**CORRESPONDENCE COVER SHEET
WASTE PERMITS DIVISION
TEXAS COMMISSION ON ENVIRONMENTAL QUALITY**

Date: May 17, 2019
 Facility Name: City of Kingsville Landfill
 Permit or Registration No.: MSW 235-C

Re: City of Kingsville Landfill – Kleberg County
Municipal Solid Waste (MSW) - Permit No. 235C
Permit Amendment Application – Supplemental Information
Tracking No. 23301130, 23458984, and 24040819; RN102334570/CN600674246

On behalf of the City of Kingsville and in response to your May 10, 2019 and May 16, 2019 email requesting supplemental information, we hereby submit the enclosed response regarding the Permit Amendment Application for the above referenced MSW facility.

- MW-20** MONITOR WELL LOCATION
- EXISTING FENCE
- EXISTING SURFACE CONTOUR (2015)
- SECTOR OUTLINE
- PERMIT BOUNDARY (175.89 ACRES)
- BUFFER ZONE
- POINT OF COMPLIANCE

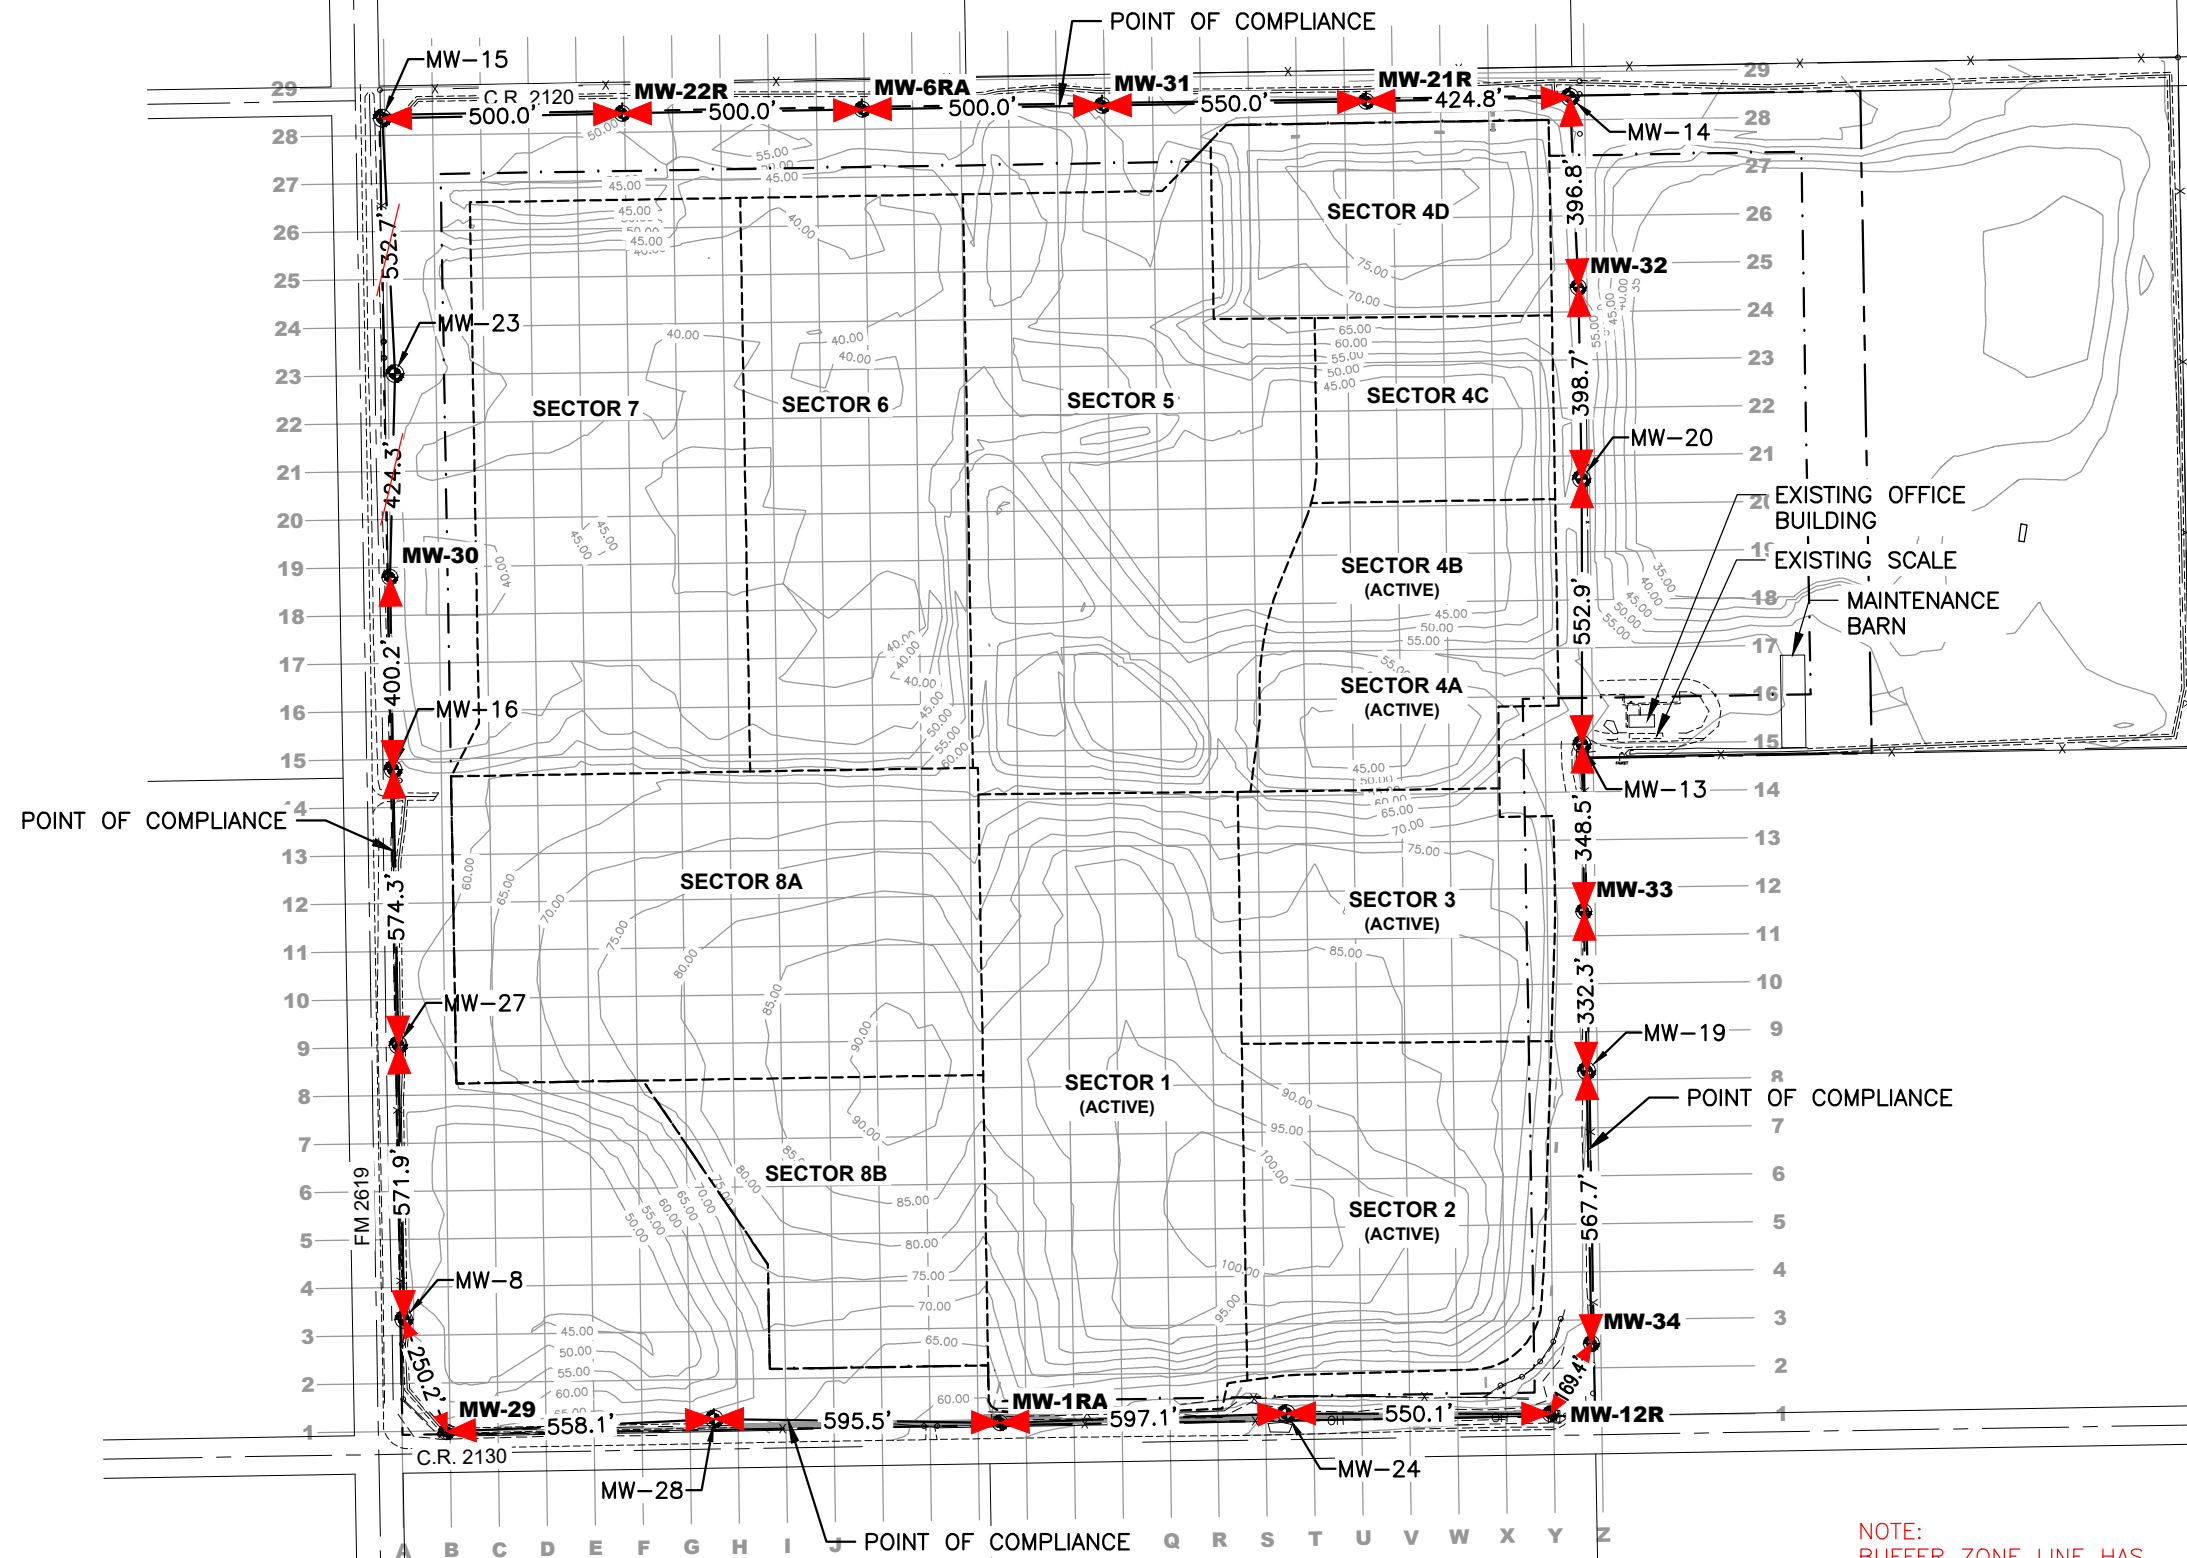
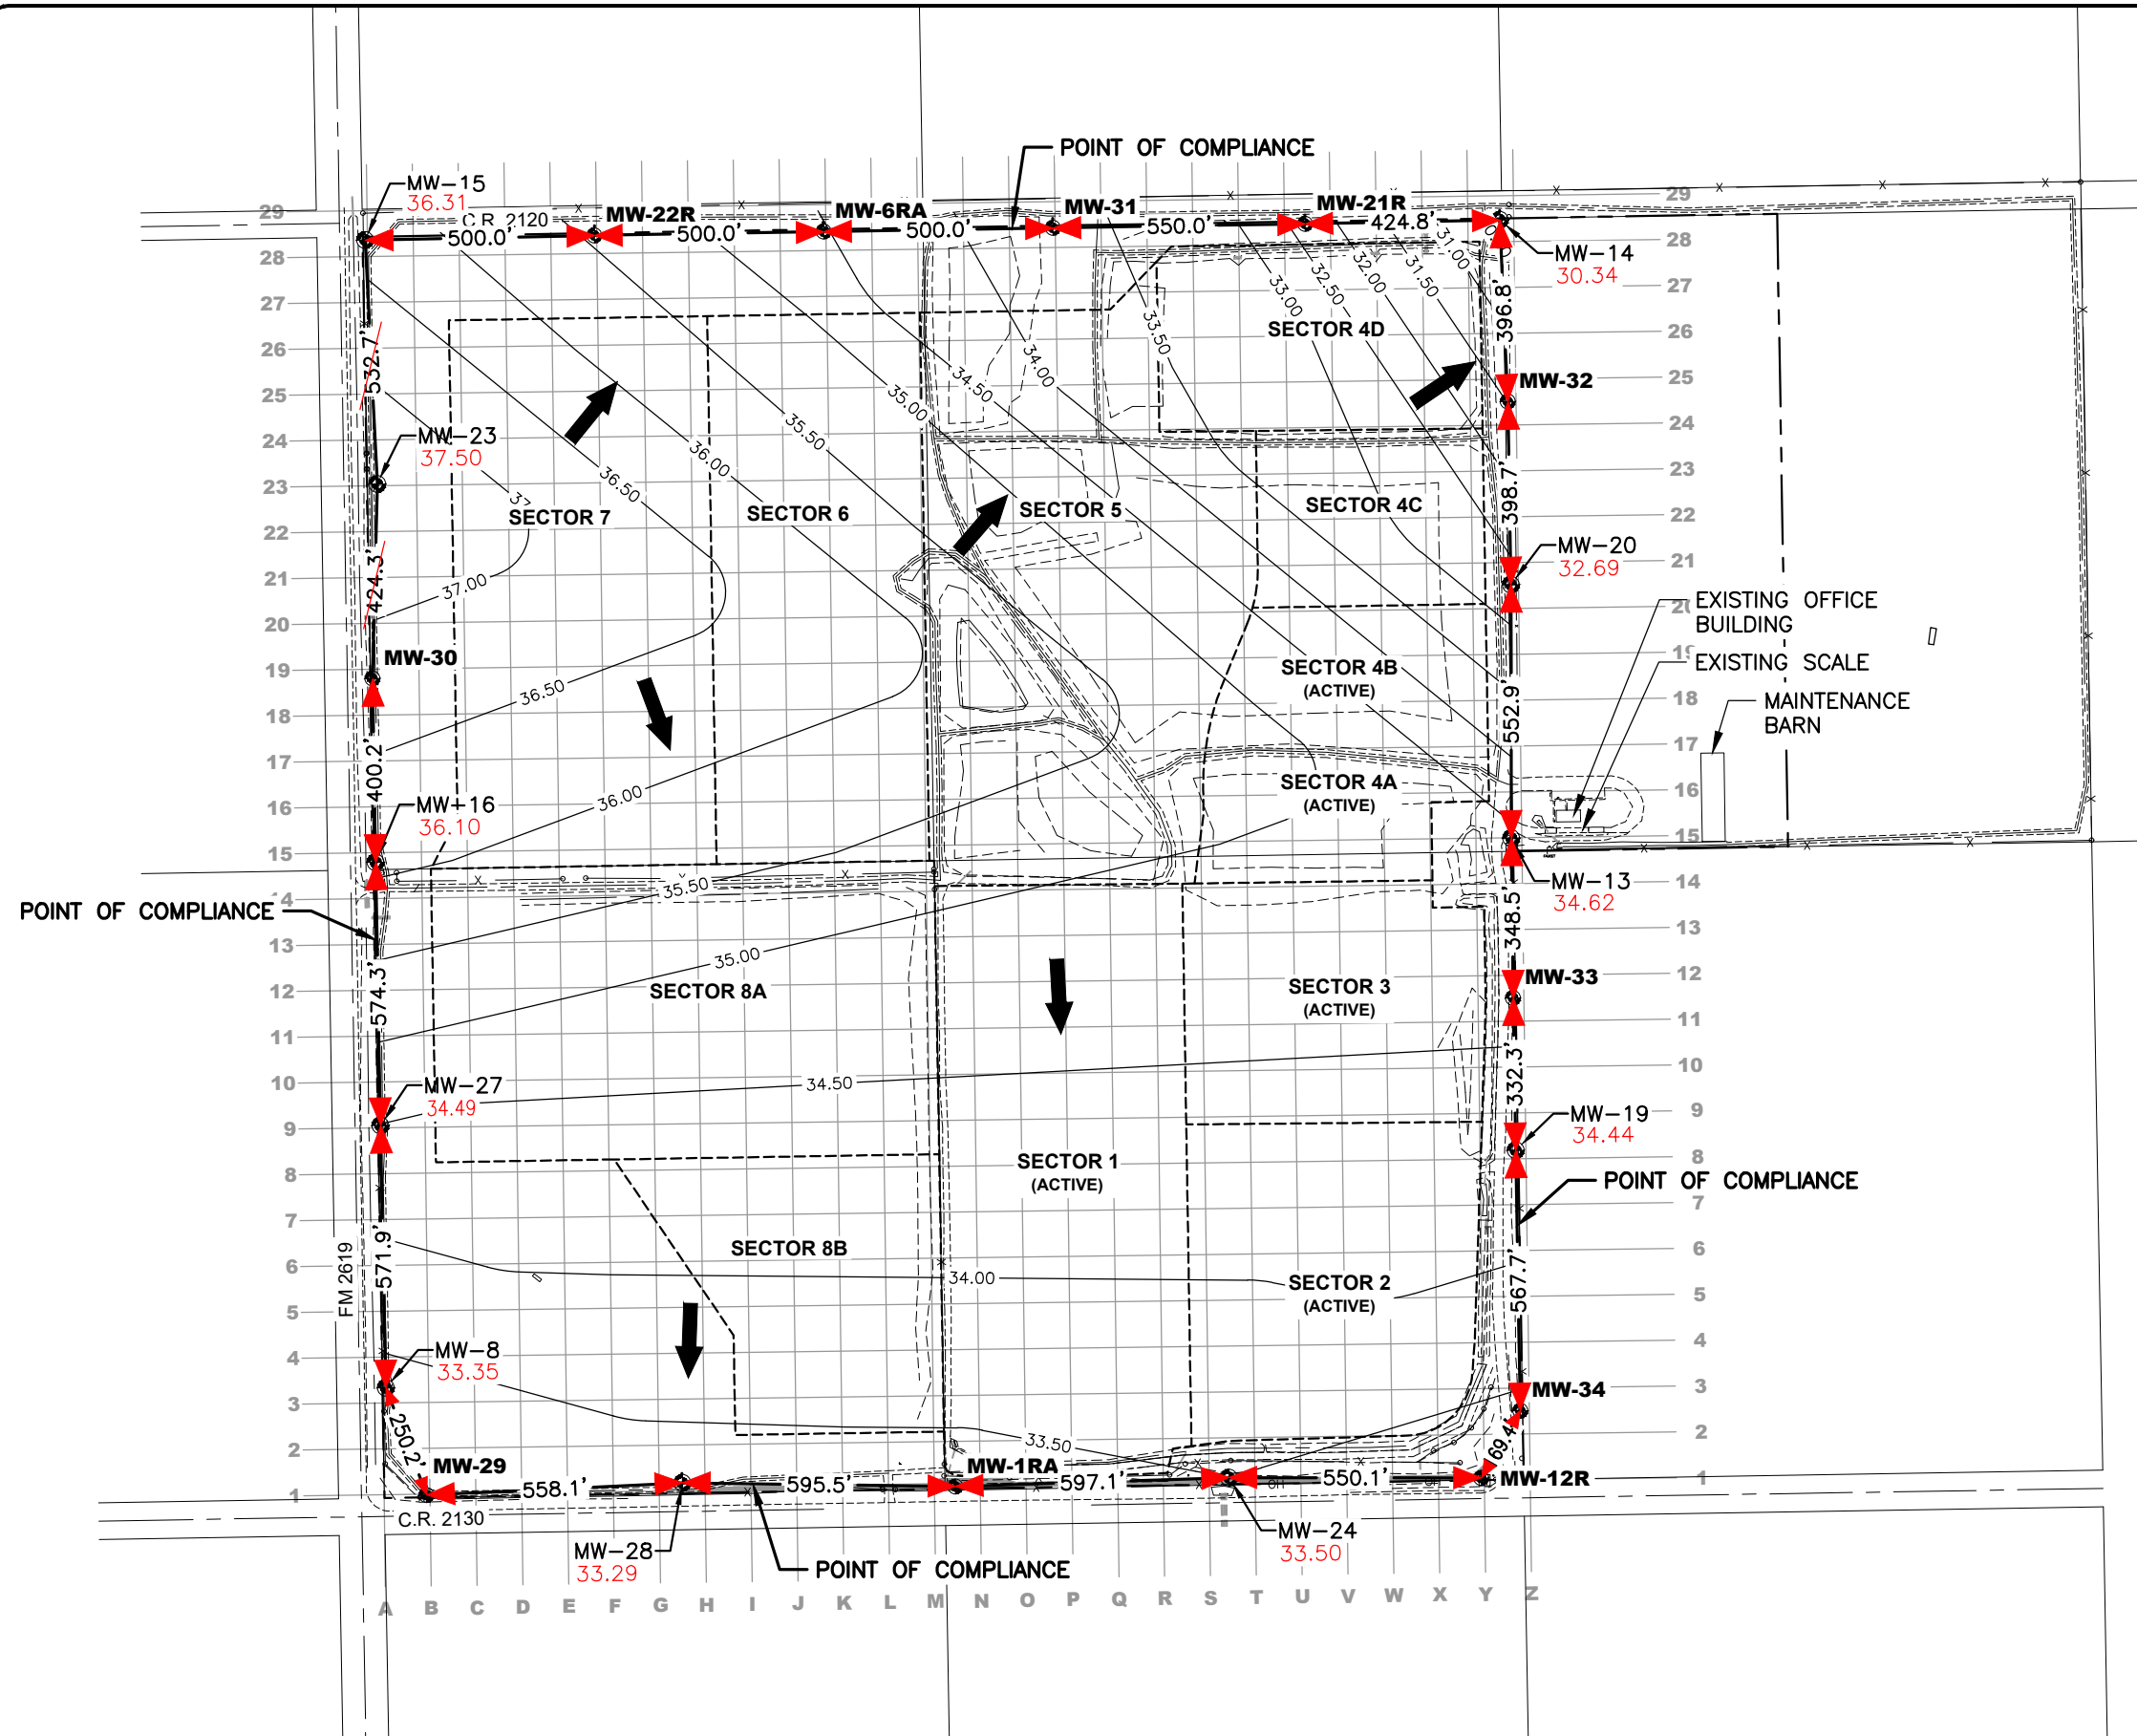
Att 11, App A, Item 1	Ambiguous
NOD Description	
Highlight the point of compliance line on Figures III.11-A-1A and 1B to more clearly show its extent, and provide a schedule for monitor well installation.

The point of compliance line on Figures III.11-A-1A and 1B has been highlighted with arrows to more clearly show its extent, and to provide a schedule for monitor well installation.
